<b>DART AEROSPACE LTD</b>	<b>Work Order:</b>	<b>94000</b>
<b>Description:</b> Crosstube Assembly (412 High Aft)	<b>Part Number:</b>	<b>D412-664-243</b>
<b>Inspection Dwg:</b> D412-664-243 <b>Rev:</b> E		<b>Page 1 of 2</b>

DRAWING NO. D412-664-243	TITLE CROSSTUBE ASSEMBLY (412 HI AFT)	REV. E	DART AEROSPACE LTD ENGINEERING ORDER		D.E.O. NO. D412-664-243-E-1	SHEET NO. SHEET 1 OF 2	SCALE NTS
DRAWN	CHECKED	MFG. APPR.	APPROVED	DE APPR.			
DATE 11.03.31	DATE 11/03/31	DATE 11.03.31	DATE 11/03/31	DATE 11-03-31

**PURPOSE:**  
REMOVED ABRASION STRIP IN FAVOR OF A THIN LAYER OF PROSEAL 890.

REMOVED ABRASION STRIP IN FAVOR OF A THIN LAYER OF PROSEAL 890. UPDATE INSTALLATION OF CHAFING SHIELDS AND REDUCE TORQUE TO 40-50 IN-LBS. THIS ENGINEERING ORDER SUPERCEDES DEO D412-664-243-E-1.

**D412-664-243  
ASSEMBLY DETAIL**

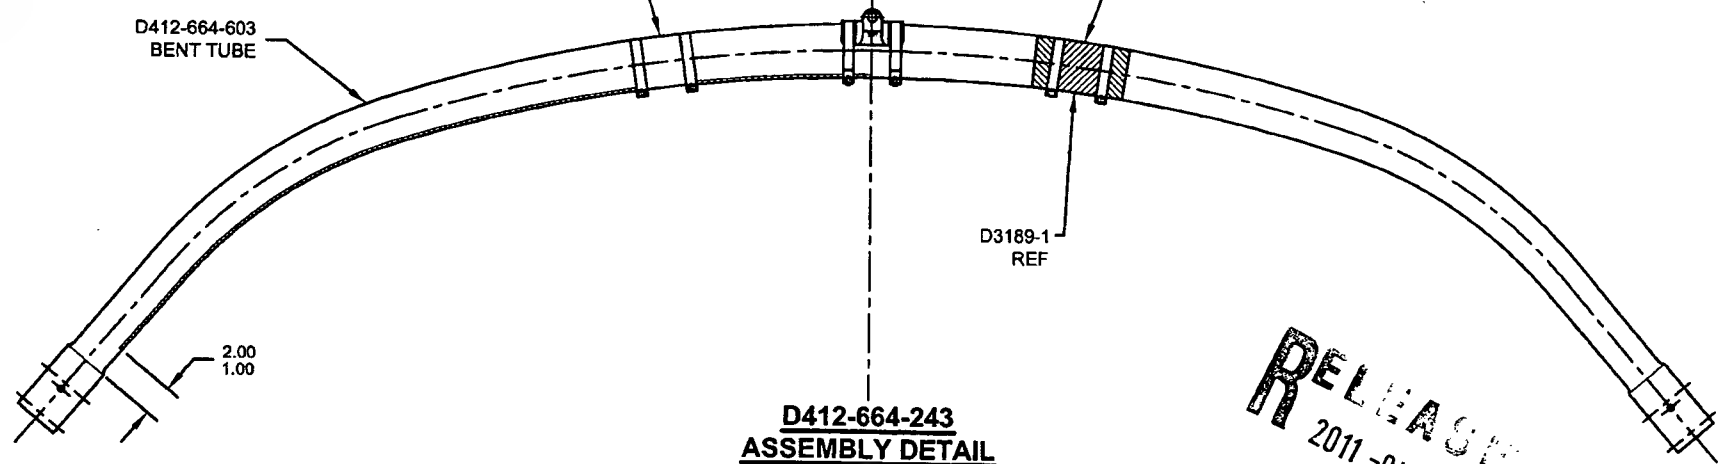
**IS:**

D3189-1 CHAFING SHIELD (1, INSTALLED OVER PROSEAL 890)  
MS21920-28 CLAMP, 2X  
2 PL

**WAS:**

D2856-600-1009 ABRASION STRIP  
D3189-1 CHAFING SHIELD (1, INSTALLED OVER ABRASION STRIP)  
MS21920-28 CLAMP, 2X  
2 PL

**D412-664-243  
ASSEMBLY DETAIL**

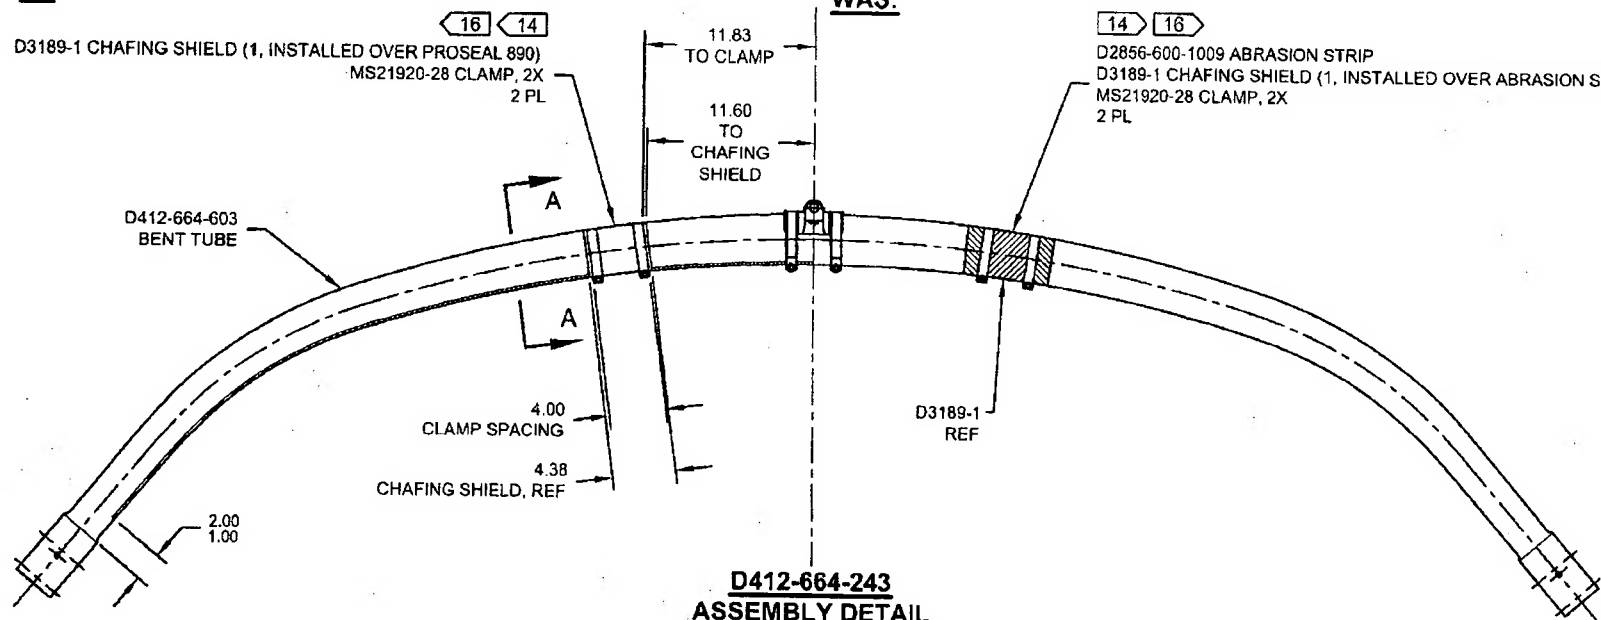
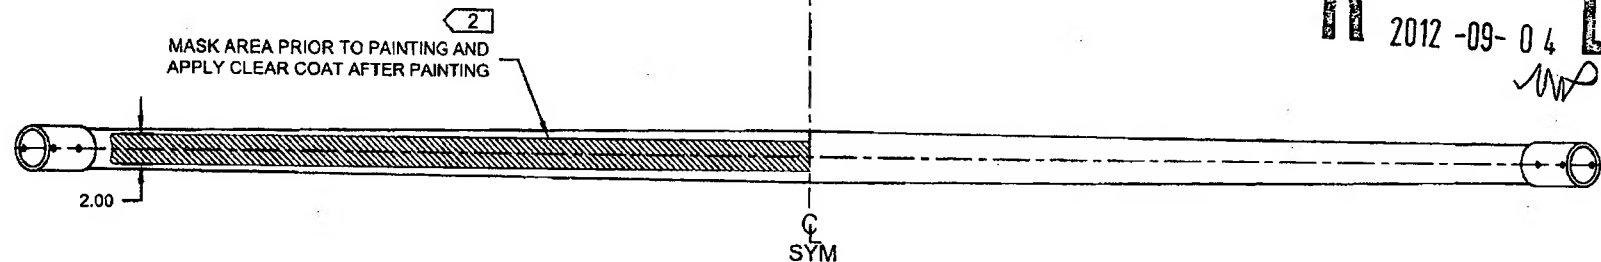
**IS:**

D3189-1 CHAFING SHIELD (1, INSTALLED OVER PROSEAL 890)  
MS21920-28 CLAMP, 2X  
2 PL

**WAS:**

D2856-600-1009 ABRASION STRIP  
D3189-1 CHAFING SHIELD (1, INSTALLED OVER ABRASION STRIP)  
MS21920-28 CLAMP, 2X  
2 PL

MASK AREA PRIOR TO PAINTING AND  
APPLY CLEAR COAT AFTER PAINTING
